Subject: AP1000 Response to Request for Additional Information (SRP 6)

RAI-SRP6.2.2-SRSB-03 R2

AP1000 TECHNICAL REPORT REVIEW

RAI Response Number: RAI-SRP6.2.2-SRSB-03

View of PXS Room Potential Break Elevations

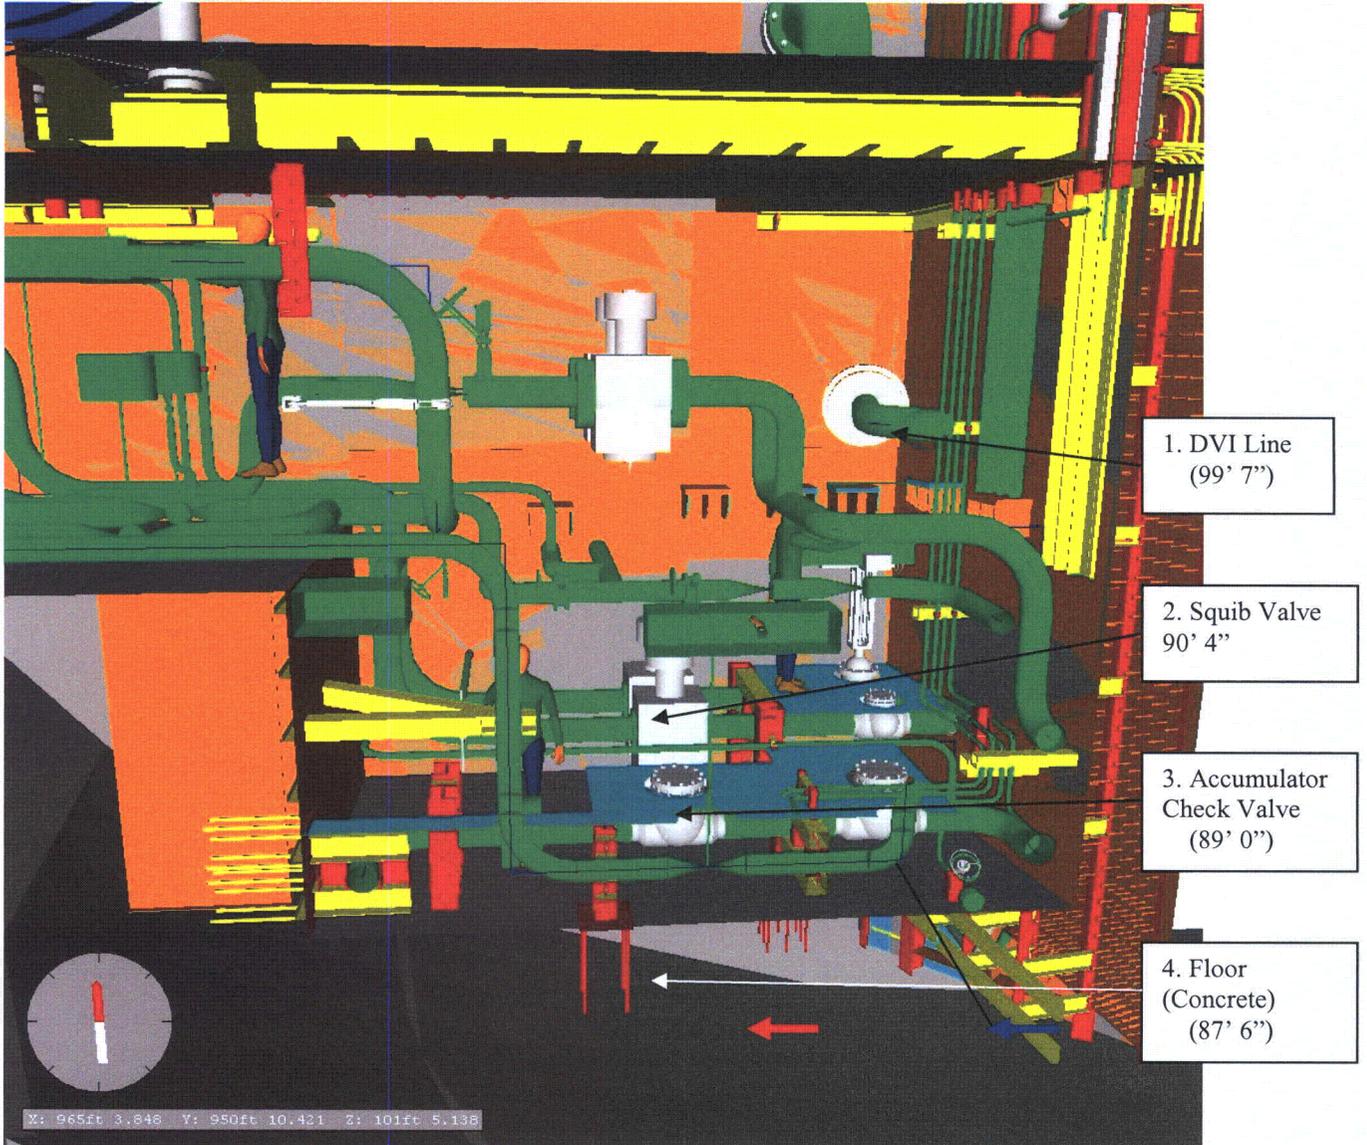
unfiltered flow going into the broken DVI pipe leading to the reactor vessel. This evaluation was not provided by Westinghouse.

- b. The RAI response states that the thermal hydraulic conditions associated with a postulated break for the AP1000 are the same as those for current operating PWRs. However, the break conditions for AP1000 may be significantly different especially for a DVI break. What is the velocity of the break when water is flowing into the reactor vessel through the break? Will this be larger than .2 ft/sec, which is the velocity that Westinghouse referred to from NUREG/CR-6808?

- a. The density of MRI (stainless steel) is much greater (about 8 times) than water density, such that it will settle out readily when the water flows / turbulence due to RCS blowdown has decreased. Small fines from MRI would be moved around the room during the initial blowdown, however once ADS 1/2/3 has been actuated the RCS pressure will decrease substantially and allow the MRI fines to settle out. After the flooding level has increased over the break and after RCS pressure is overcome by the static head of flood water, water starts flowing back into the RCS through the break.

The figure on the following page provides potential break location elevations in comparison with the room floor elevation. Please note that the lowest of these elevations, designated as the accumulator check valve will not exhibit the flow back into the RCS through the break because the IRWST flow will be either spilling or entering the RCS through this line. This can be seen in the Passive Core Cooling sketch provided.

The associated velocities on the floor can be calculated using the break elevation with a flow area associated with a hemisphere of radius R that corresponds to the distance from the break centerline to the floor, and the maximum core flow rate (60% through the break and 40% through the intact line). Response to RAI-SRP6.2.2-SRSB-10, Revision 1 provides the justification for the flow split through the break DVI line and the intact DVI line. Item 4 in Table 1 displays the calculated flow velocity for a CL

Break Location	Max. Flow Rate	Flow Area	Distance from floor to break centerline	Velocity at Floor
1	DVI nozzle	1325 gpm * 60% (for One Line) = 795 gpm = 1.771 ft ³ /s	917.38 ft ²	12.1 ft	0.00193 ft/s
2	Squib Valve	1.771 ft ³ /s	50.44 ft ²	2.83 ft	0.0351 ft/s
3	Check Valve	1.771 ft ³ /s	14.14 ft ²	1.5 ft	0.125 ft/s
4	CL Break	2600 ¹ gpm = 5.69 ft ³ /s	2440.5 ft ²	19.71 ft	0.00233 ft/s

Passive Core Cooling Sketch

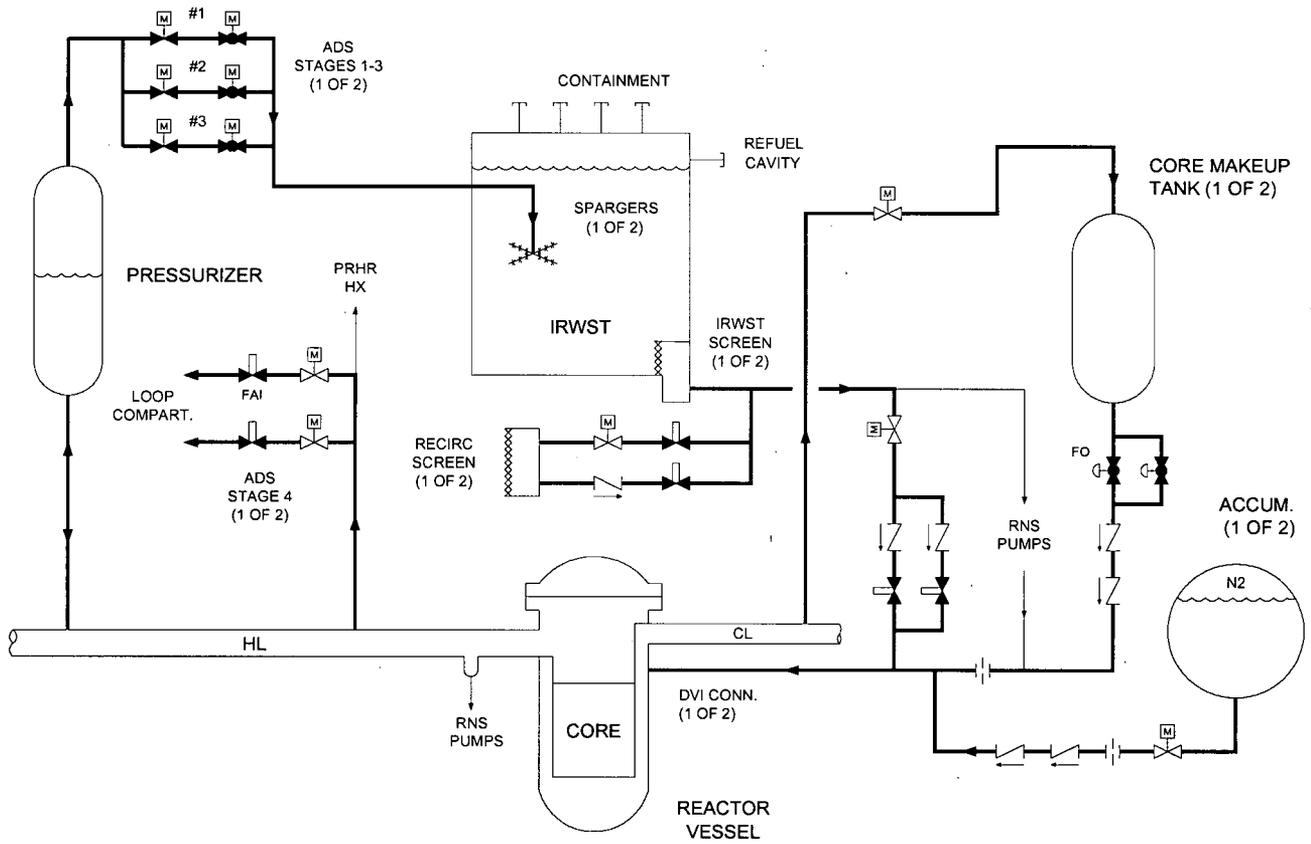
- a. Westinghouse's response implied that this RAI regarding MRI is satisfied since NEI 04-07 provides information on the transport of MRI and is accepted by the NRC SER on NEI 04-07. However, though NEI 04-07 indicates that small fines from MRI could be transported to the sump, in AP1000 the small fines from MRI could be transported directly to the open
